CITY OF ALBUQUERQUE

RE: **Lot 19 Block 5, Unit 18, S.A.D. 228**
Volcano Cliffs Subdivision
6620 Sujeto Rd. NW
Grading and Drainage Plan
Engineers Stamp Date 9/10/2020 (D10D003K19)

CITY OF ALBUQUERQUE, BERNALILLO COUNTY		NEW MEXICO					
LOT 19, BLOCK 5, UNIT 18 VOLCANO CLIFFS SUBDIVISION							
OLIVAS, JONATHAN (M. SANCHEZ) – GRADING & DRAINAGE PLAN							
McDowell Engineering, Inc. 7820 BEVERLY HILLS AVE. NE • ALBUQUERQUE, NM 87122 TEL: 505-828-2430 • FAX: 505-821-4857							
Designed	JSM	Drawn	STAFF	Checked	JSM	Sheet	of
File	OLI0120L		Date	SEPTEMBER, 2020		1	1

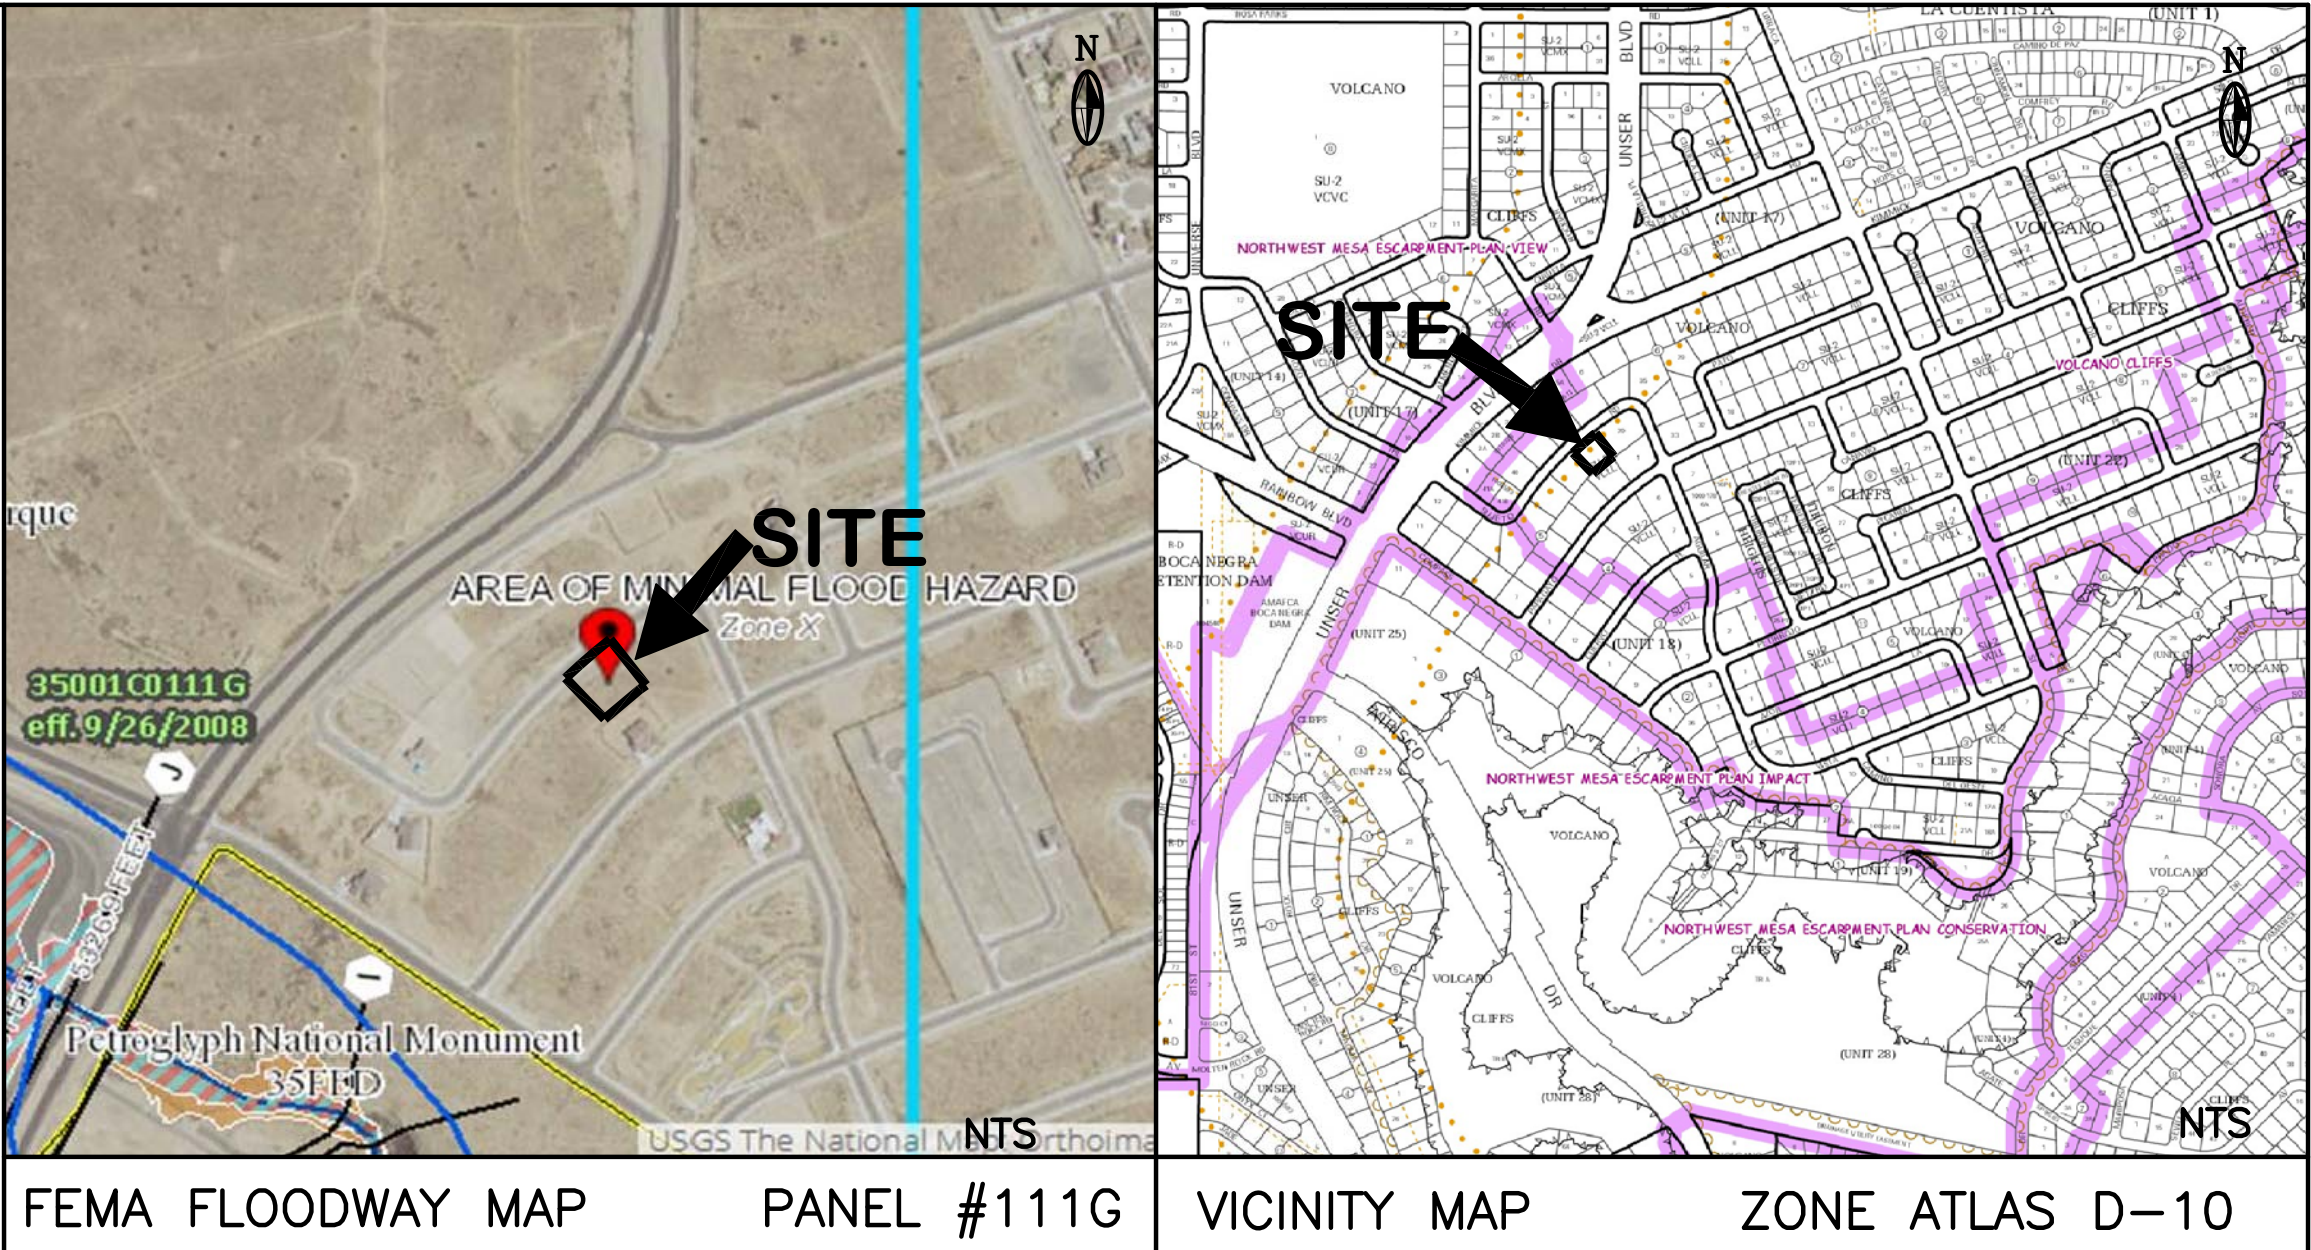
Based upon the information provided in your submittal received 8/7/2020, this plan is approved for Grading Permit.

Prior to Building permit approval a Pad Certification will be required, provided by the Engineer or a registered Land Surveyor.

Reiterate to the Owner/Contractor that a separate permit for a garden/retaining wall must be obtained, with the approved G&D plan dated 7/28/2020.

Prior to Certificate of Occupancy release, Engineer Certification per the DPM checklist of this plan will be required.
